## The McDaniel Company P&A Procedure

ALPHA ENERGY PARTNERS LLC  
 TRACY B COM #001  
 API: 30-015-21416  
 EDDY COUNTY, NM

**APPROVED**  
**GC 3/18/26**

Operator: Alpha Energy Partners LLC PO Box 10701 Midland, TX 79702	OGRID: 330859
	Action Number: 564051
	Action Type: [C-103] NOI Plug & Abandon (C-103F)

# Proposed WBD

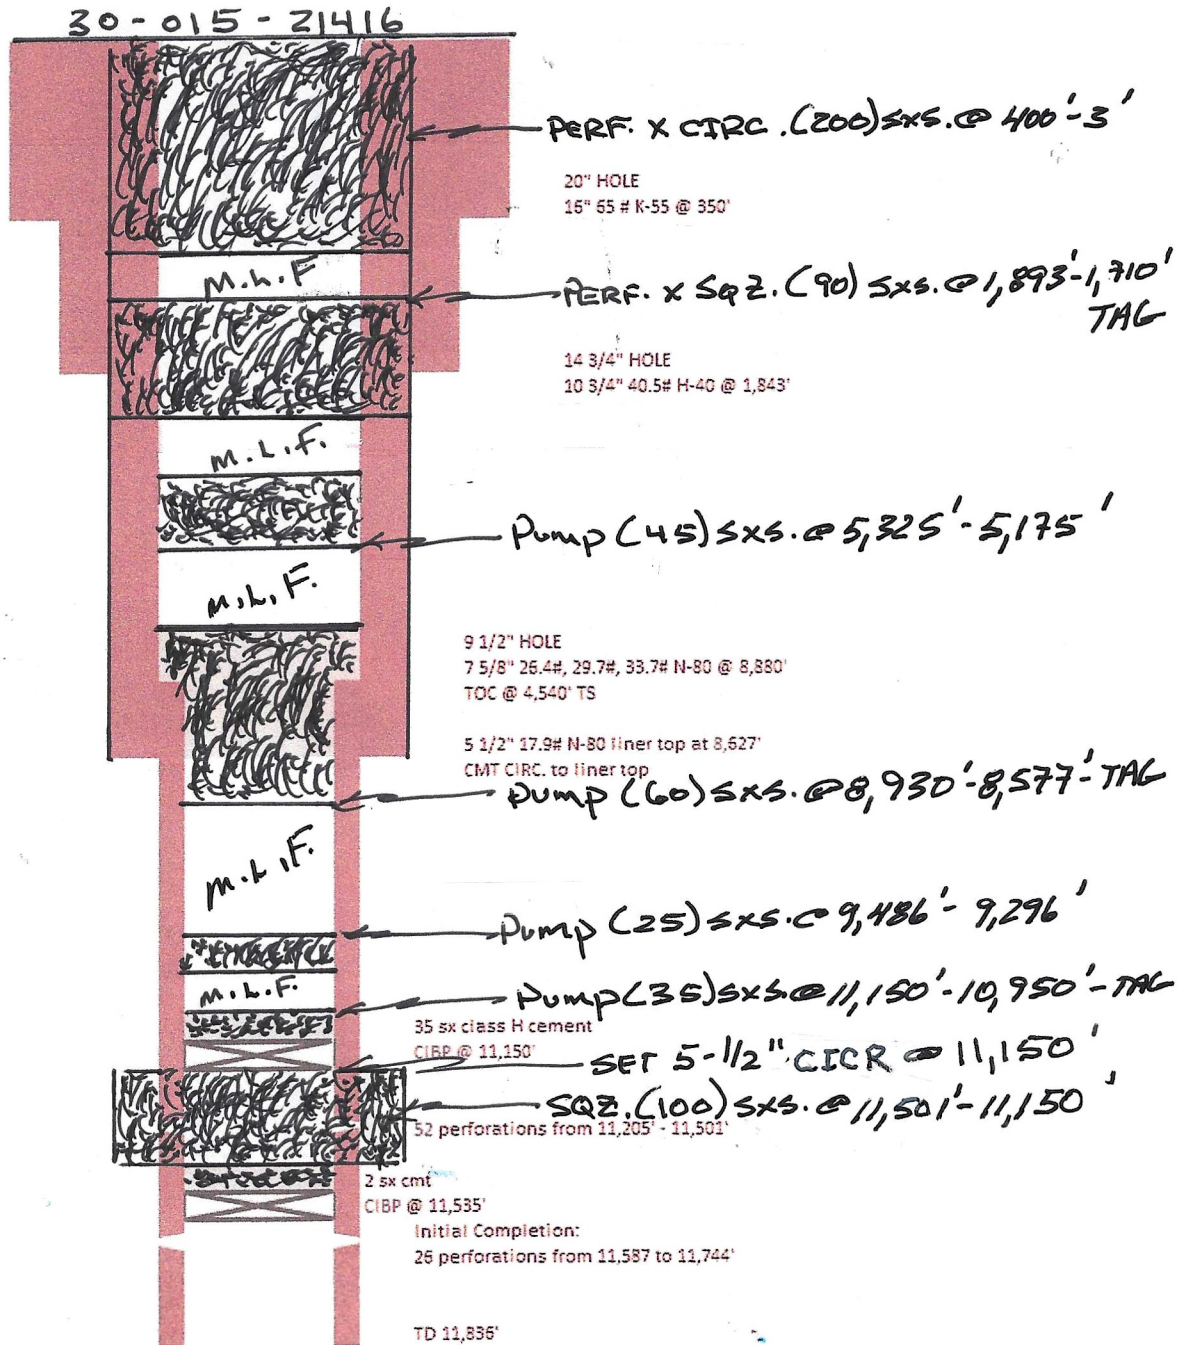
12. Spot 35 sx cmt 10530' - 9830' - T Atoka, Penn
13. RIH W/ TBG TO 9,486'.
14. MIX & SPOT A 25 SX CMT PLUG FROM 9,486'-9,296'.
15. POOH W/ TUBING TO 8,930'

19. Spot 25 sx cmt 3500' - 3200' - required spacer
20. POOH W/ TUBING TO 1,850'
21. RU WLU & MAKE UP PERF GUN. RIH & SHOOT SQZ HOLES @ 1,893'. POOH & RD WLU.
